ACCESS 8 AH V2.0 Installation note

Picture 1. Adding capacitors to WIE-lines

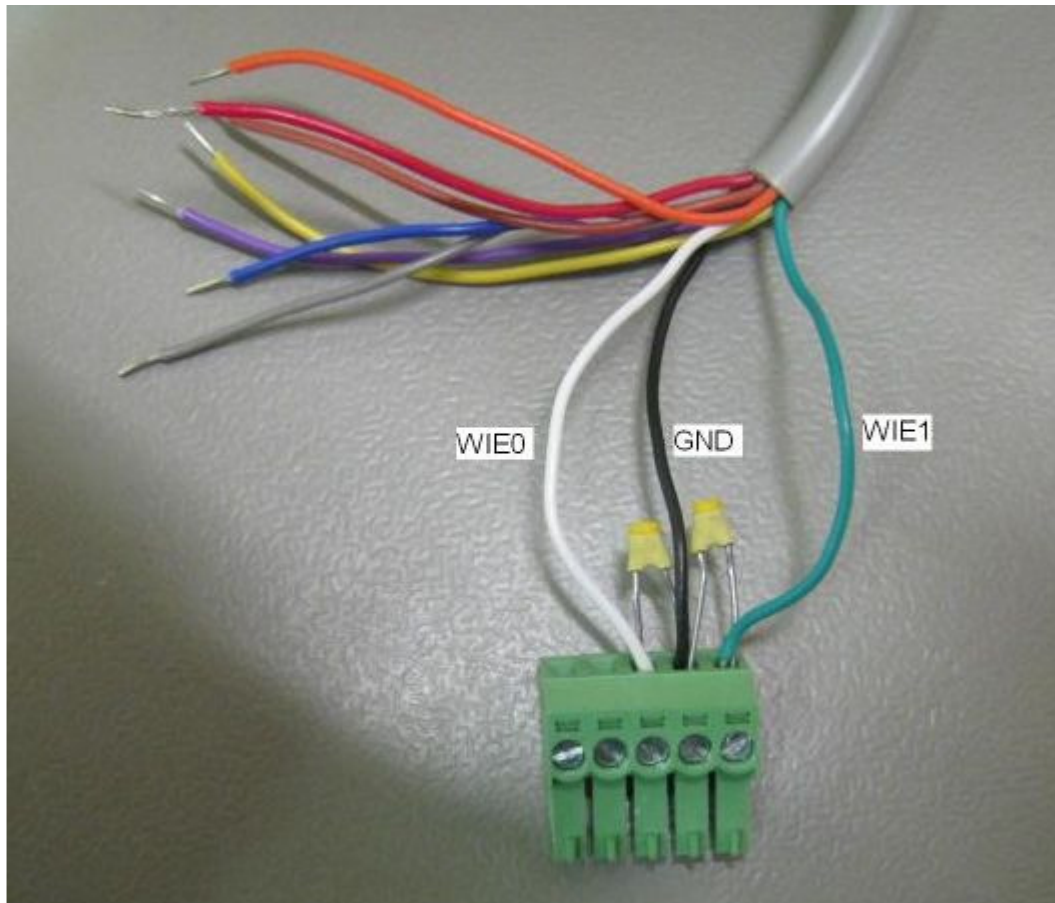
1. Add 1nF capacitors between WIE0 & GND and WIE1 & GND as in picture 1 to improve Wiegand signal quality.
